Appl. No. 10/706,323
Amdt. Dated March 2, 2006
Reply to Office Action of November 2, 2005

Amendments to the Drawings:

REMARKS/ARGUMENTS

FIG.7(a) *Prior Art* - ADDED

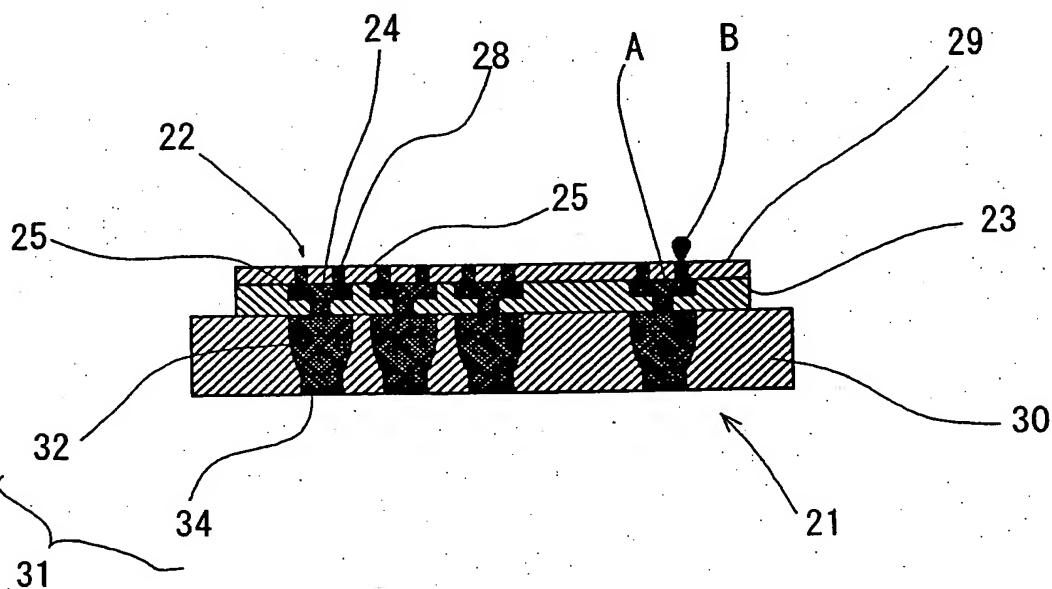
The attached sheet of drawings includes changes to Fig. 7-10. In Figures 7(a), 7(b), 8(a)-8(c), 9(a)-9(c), and 10(a)-10(c), previously omitted element "Prior Art" has been ADDED.

Figures 7, 8, 9, and 10 were objected to for missing “prior art” designation. In response, Applicant has amended the figures to include “prior art” designation, and is submitting the amended figures with the current submission. Reconsideration and withdrawal of the above objection are respectfully requested.
